Re: Seminole Electric Cooperative, Inc.
Seminole Generating Station, Putnam County, Florida
Power Plant Certification No. PA78-10
Post-Certification Amendment to Application

Subject: Seminole Electric Cooperative Inc.'s (SECI's) Seminole Generating Station (SGS)

Environmental Consulting & Technology, Inc. (ECT), is submitting this hydraulic analysis to assess stormwater runoff from the proposed 1,525 square foot (ft²) concrete slab near an existing welding shop, a proposed 15- by 30-ft shed in an existing lube oil storage area, and the proposed 1,320 ft² concrete slab near an existing EPF maintenance building.

FIGURE 1.
SGS WELDING SHOP SITE PLAN

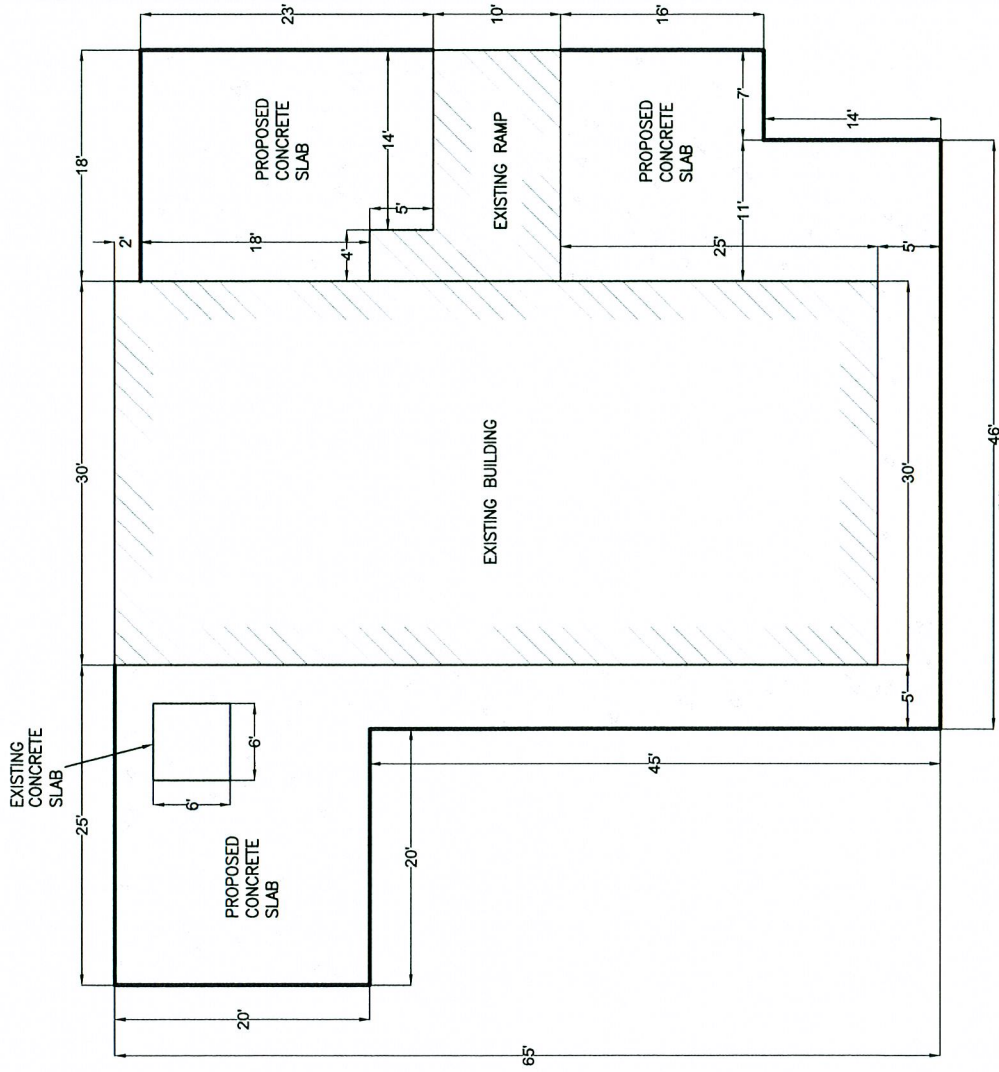
SECI plans to construct a 1,525 ft² concrete slab on mostly grassy areas adjacent to an existing welding shop (Figures 1 and 2). The purpose of the concrete slab is for equipment staging before fabrication. The slab addition will slightly increase the impervious surface area and thus more stormwater runoff to the detention pond #1. In addition, SECI plans to construct a 15- x 30-ft shed to store lube oil in an area currently covered by impervious asphalt (Figure 2). The lube oil storage area also drains into detention pond #1. The construction of the proposed storage shed will not have any hydrologic impact because it will be constructed on an existing impervious area. To assure that the existing pond #1 has sufficient storage capacity to attenuate the runoff from the concrete slab, ECT conducted a hydraulic/hydrologic analysis as described in the following paragraphs.

FIGURE 2.
SEMINOLE GENERATING STATION STORMWATER BASIN #1 LAND USE
SEMINOLE ELECTRIC COOPERATIVE, INC.

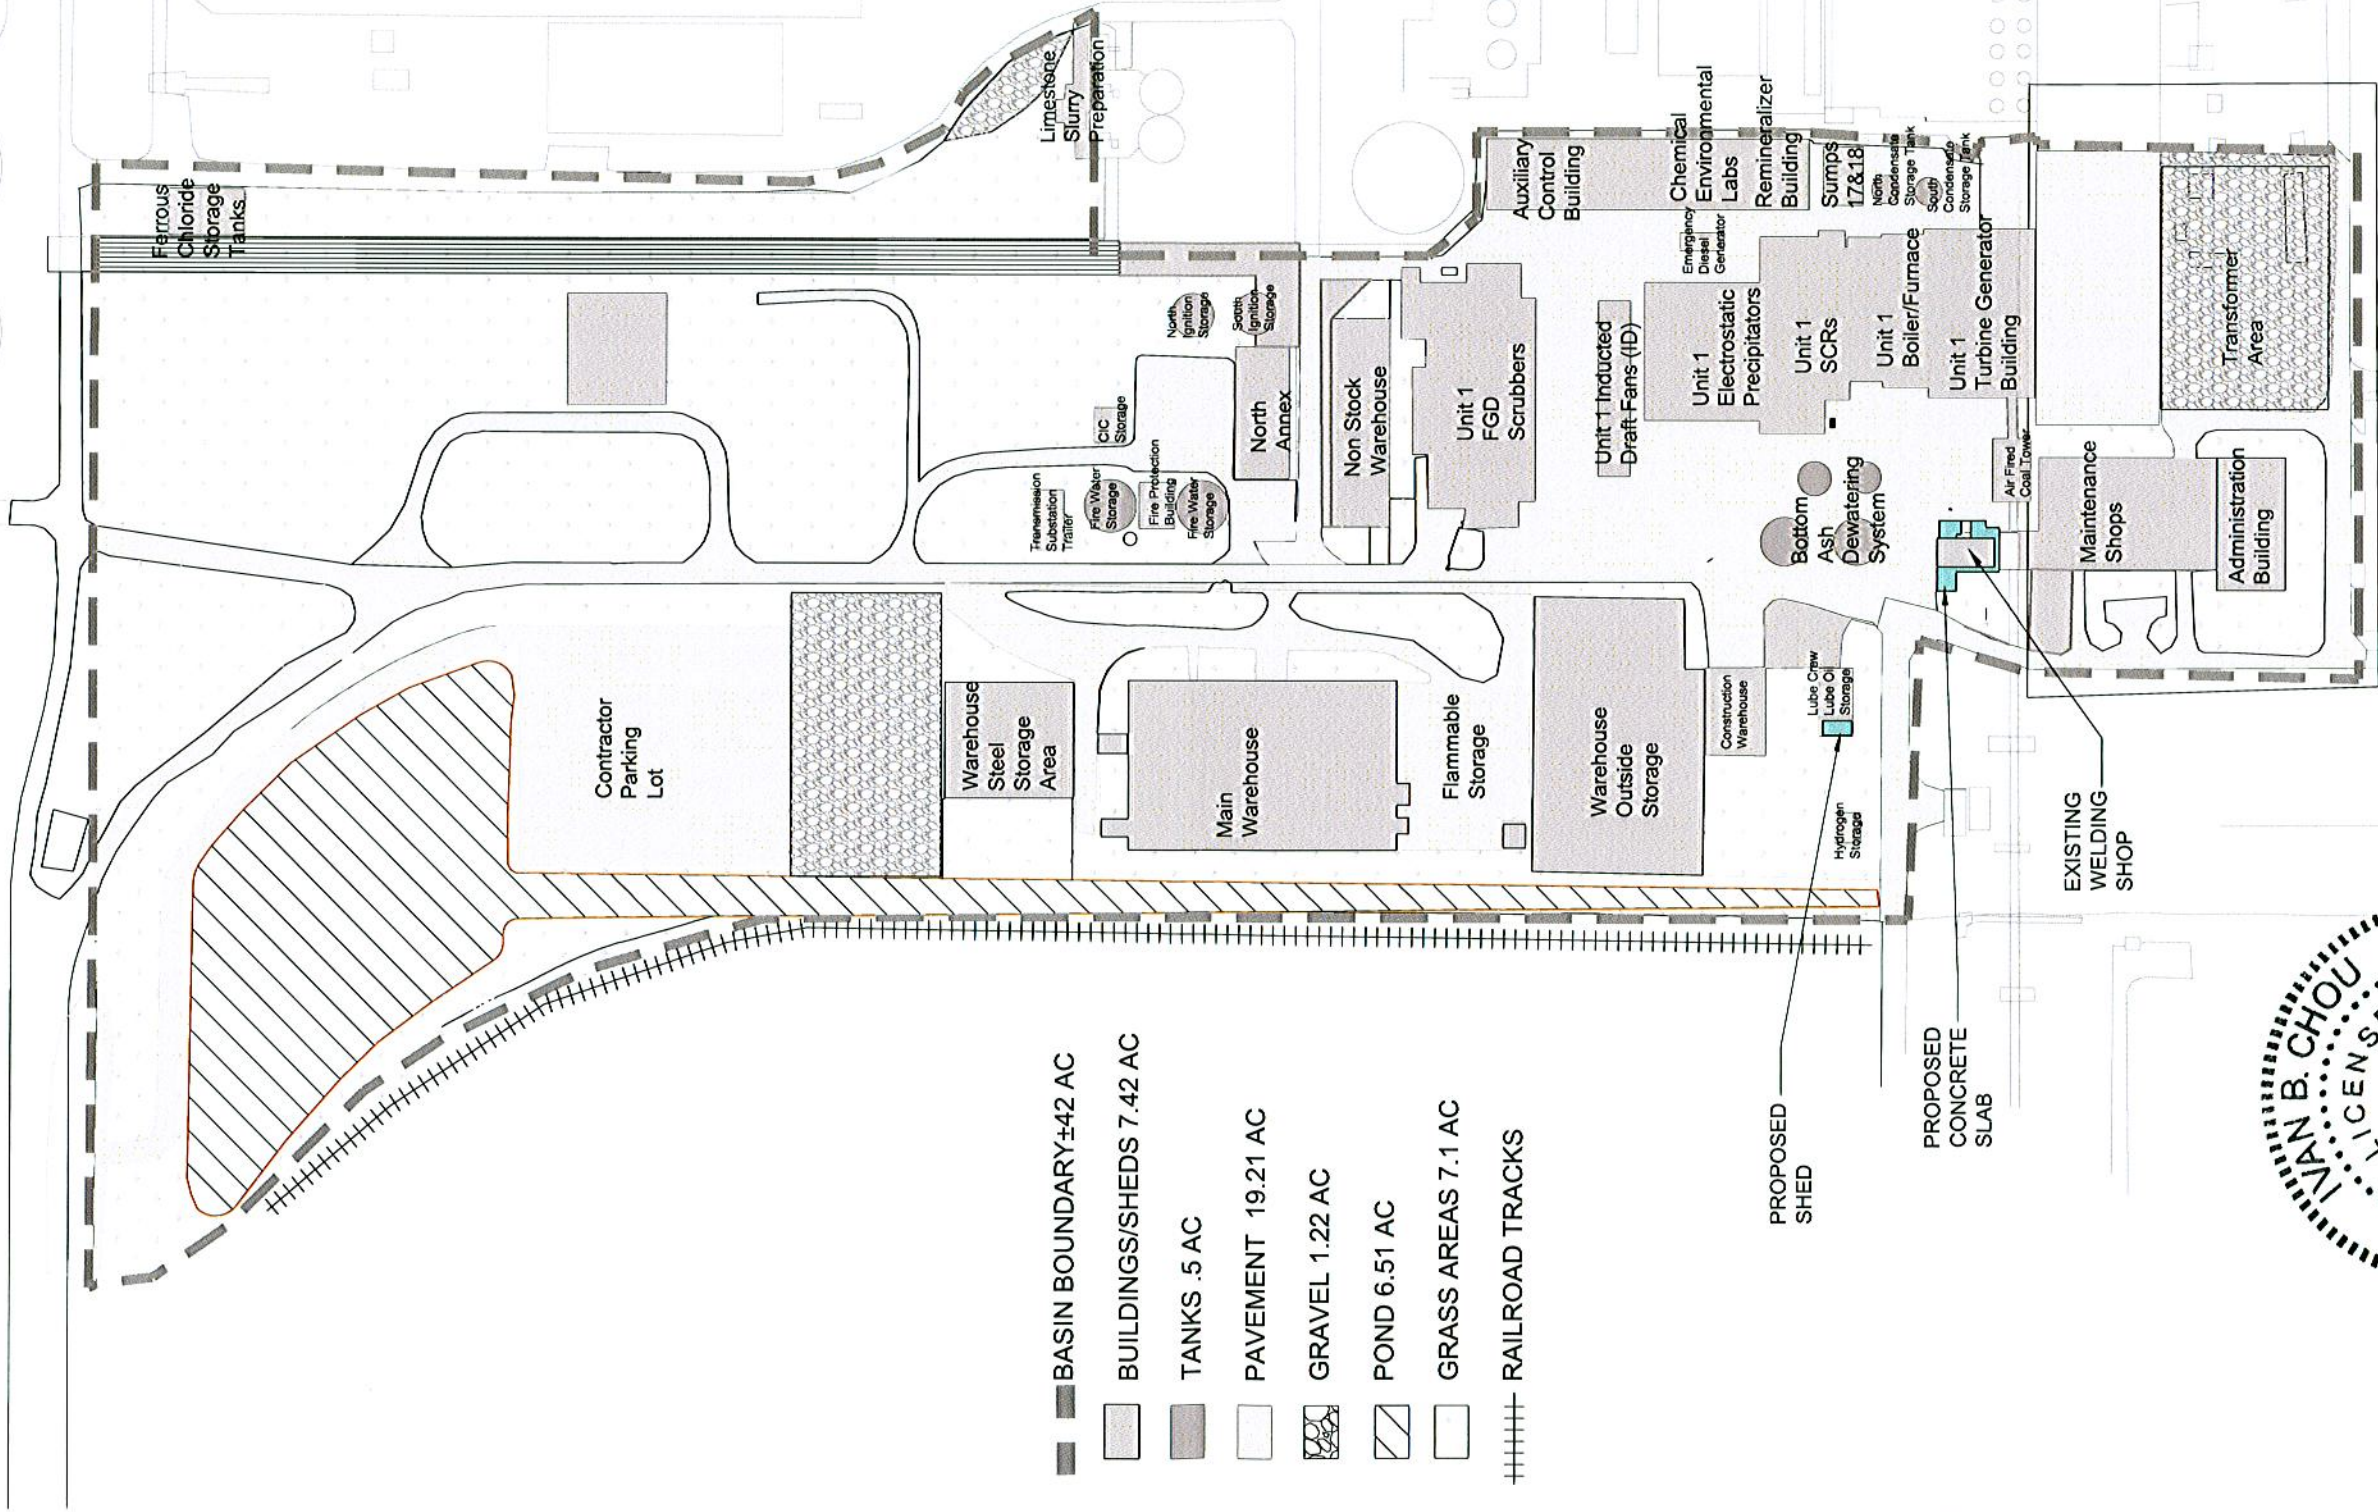
To evaluate the attenuation capacity of the stormwater pond #1, hydraulic and hydrologic analyses were conducted, using HEC-HMS model, for both the pre-SCR and post-concrete slab conditions. Figure 2 shows the land use information for the stormwater basin #1, including the proposed 1,525 ft² concrete slab near the welding shop. The curve number (CN) calculations for the pre-SCR and post-concrete slab conditions are presented in Table 2.

The 27.13-acre structure and pavement area for the post-concrete slab condition includes 7.42 acres of buildings and sheds, 0.5 acre of tanks, and 19.21 acres of pavement. Both structure/pavement and gravel areas are considered as impervious. The computed weighted CNs for the pre-SCR and post-concrete slab conditions are 79.1 and 89.4, respectively.

The HEC-HMS results indicate that the peak discharge of the pond #1 under the post-concrete slab condition is less than the peak discharge under the pre-SCR condition for mean annual maximum, 25-year, and 100-year storm events. In addition, the freeboard in pond #1 at peak stage under a 100-year storm event is 1.4 ft (the stormwater pond #1 berm elevation is 77 ft-NGVD).

Therefore, the existing stormwater pond #1 has sufficient storage and attenuation capacity to accommodate the proposed concrete slab near the welding shop.

PROPOSED CONCRETE SLAB NEAR EPF MAINTENANCE BUILDING

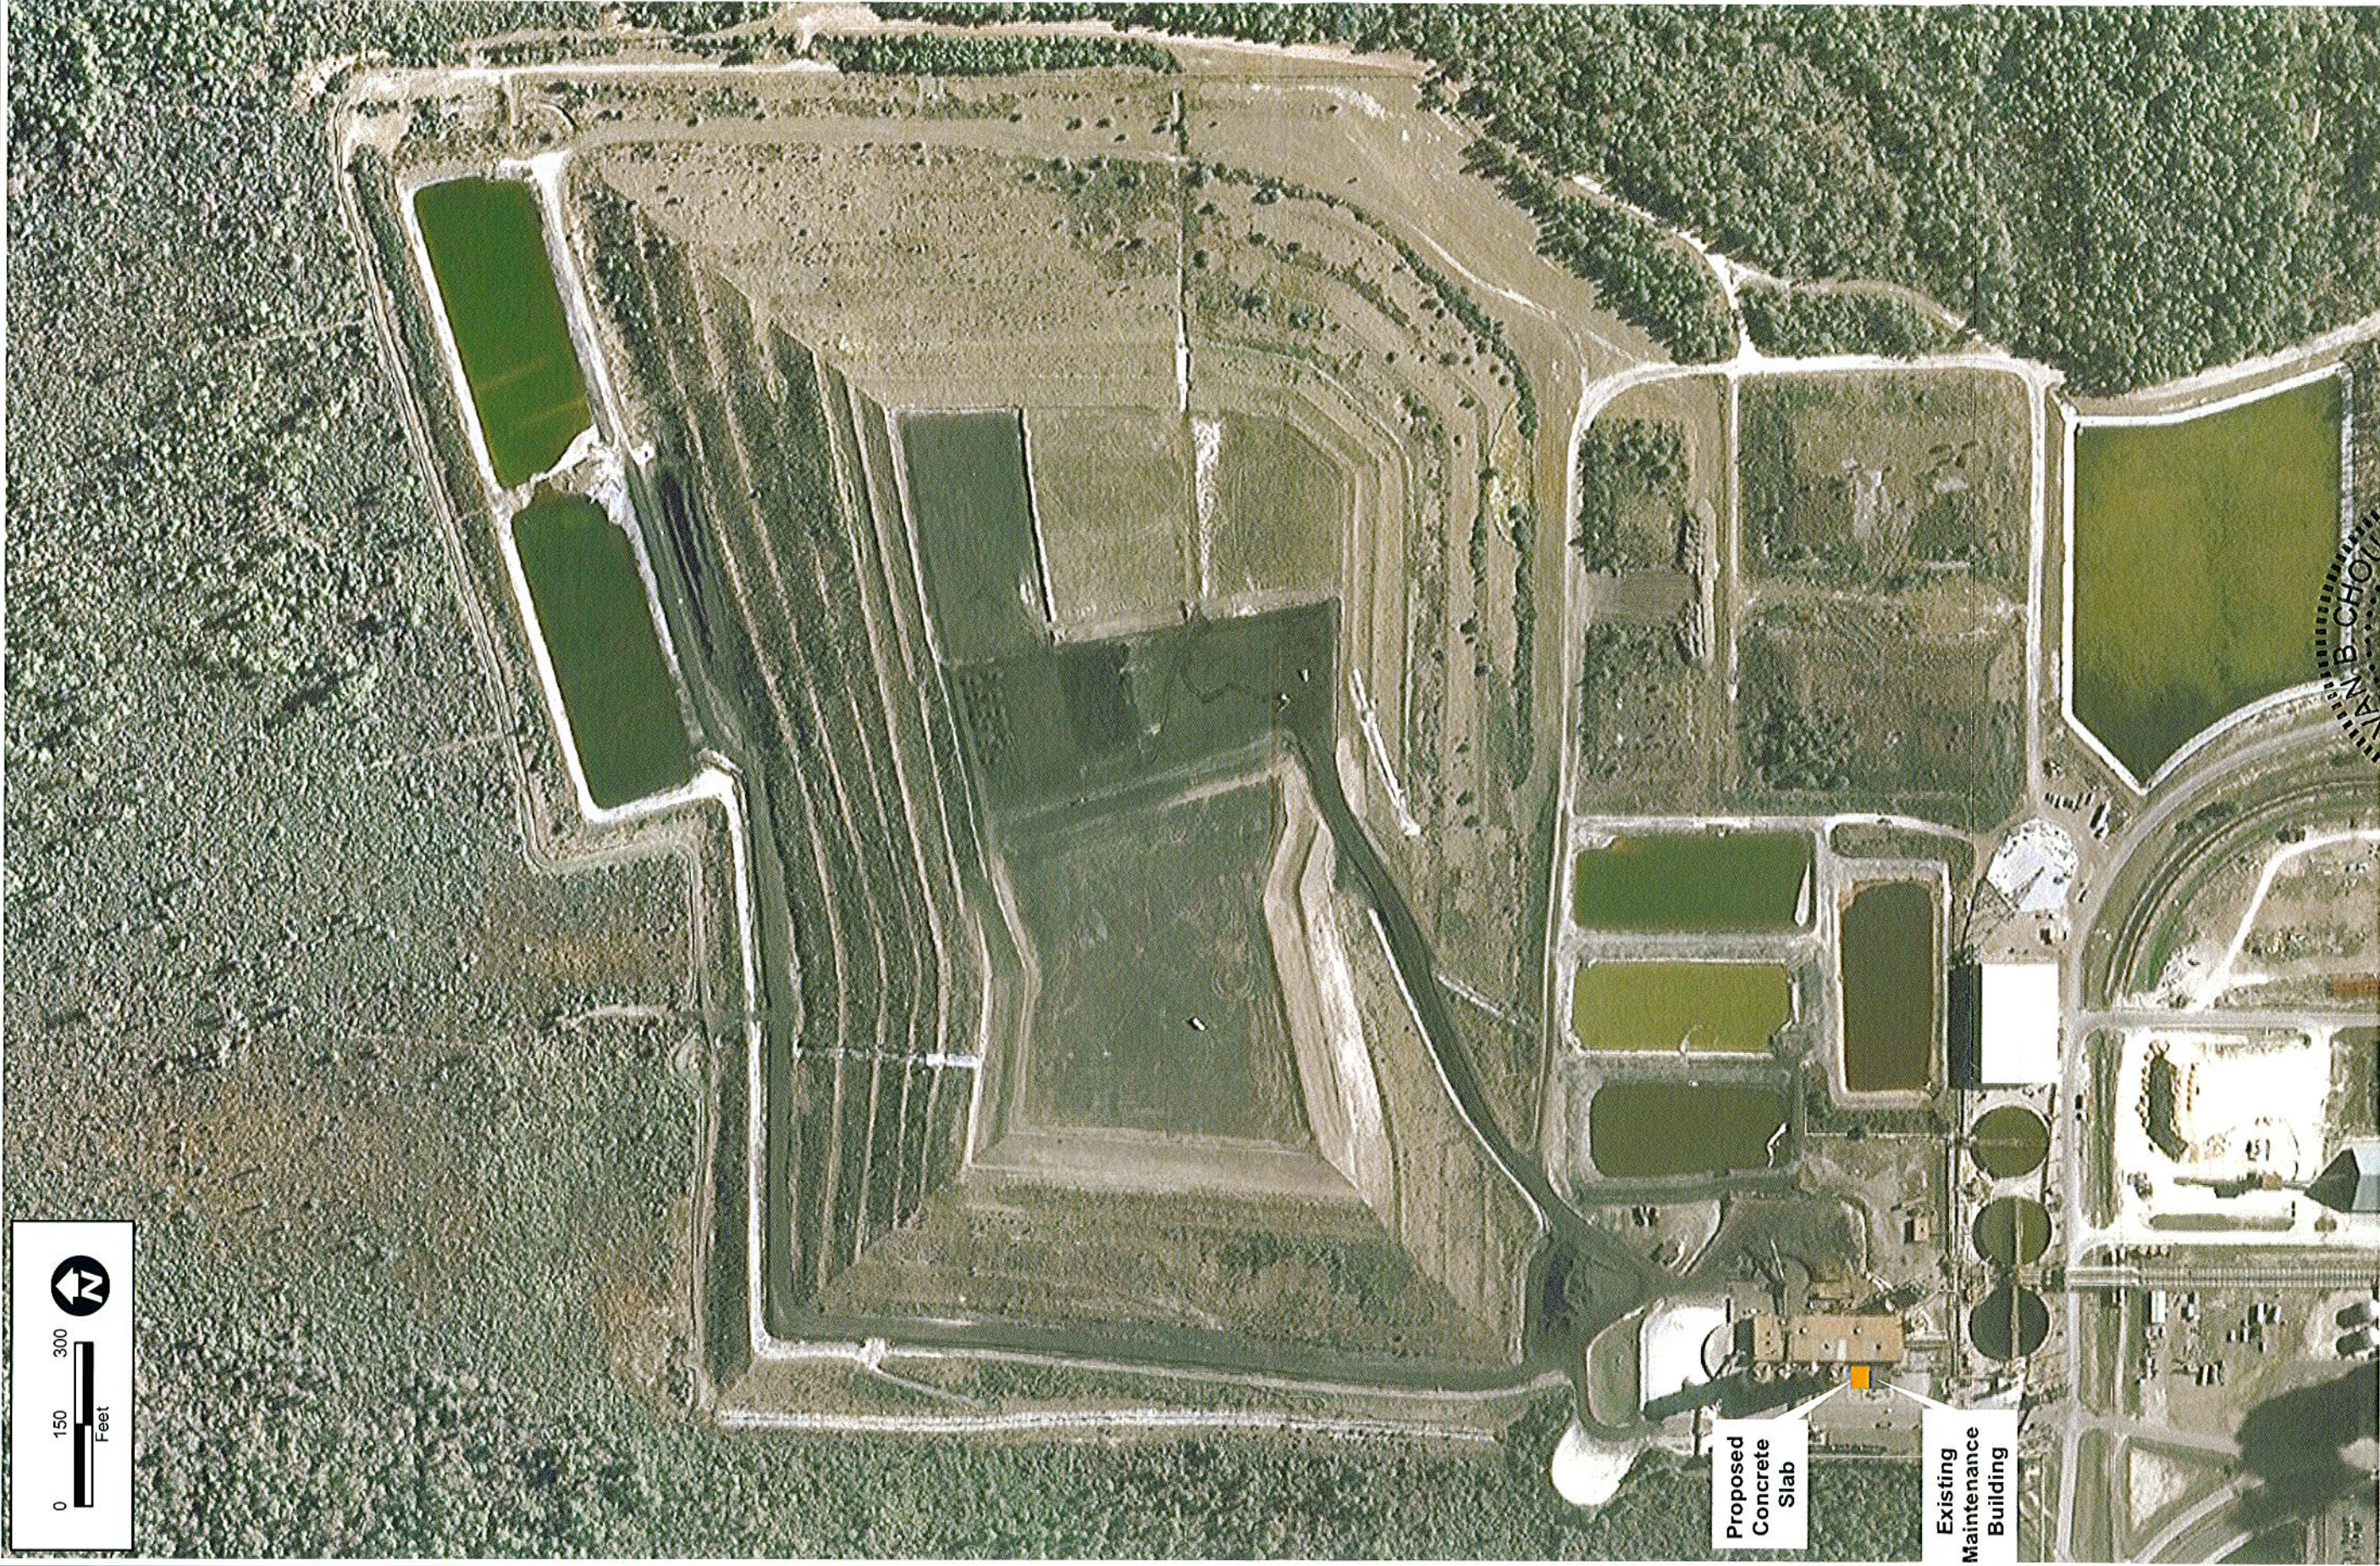
Figure 3 shows the location of a proposed 33- by 40-ft concrete slab in a currently gravel area at the north end of the existing EPF maintenance building. The purpose of this concrete slab is to increase the work area on a level surface and prevent slipping hazard on loose gravel. The runoff from the proposed concrete slab drains north and east and into four inter-connected retention ponds. These retention ponds are part of the onsite wastewater system. The pond water is either re-used or treated and does not contribute stormwater discharge to receiving waters. Therefore, the proposed 1,320 ft² concrete slab near the EPF maintenance building will not have adverse hydrological impact.
